Corrigendum to “Transition toward a fully renewable-based energy system in Chile by 2050 across power, heat, transport and desalination sectors”

This is a corrigendum to the article *Transition toward a fully renewable-based energy system in Chile by 2050 across power, heat, transport and desalination sectors* published by the International Journal of Sustainable Energy Planning and Management with DOI: <http://doi.org/10.5278/ijsepm.3385> [1]

2. Page 88: Instead of the bar graph of Figure 16 (right) it should be

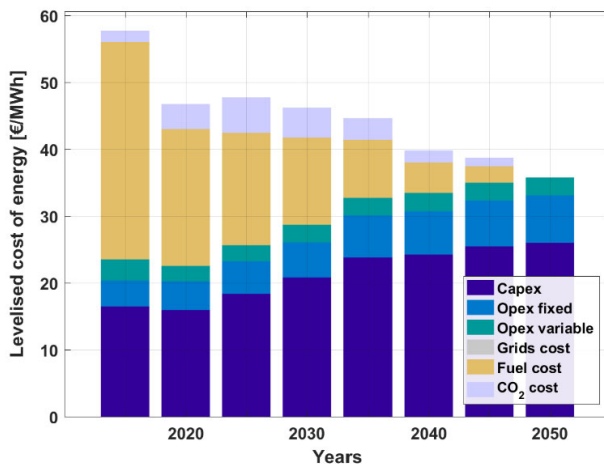
In the original published version of the article, Figure 16 (right) and the corresponding numbers in the article were incorrectly displayed. The authors regret the error. The corrected figure and text are available below.

3. Page 88: In the sentence “*However, as can be seen in Figure 16 (right), the levelized cost of energy for the full system would be reduced through the transition from about 114 in 2015 to 85 €/MWh by 2050.*”, instead of “114” and “85” it should be “58” and “36”, respectively.
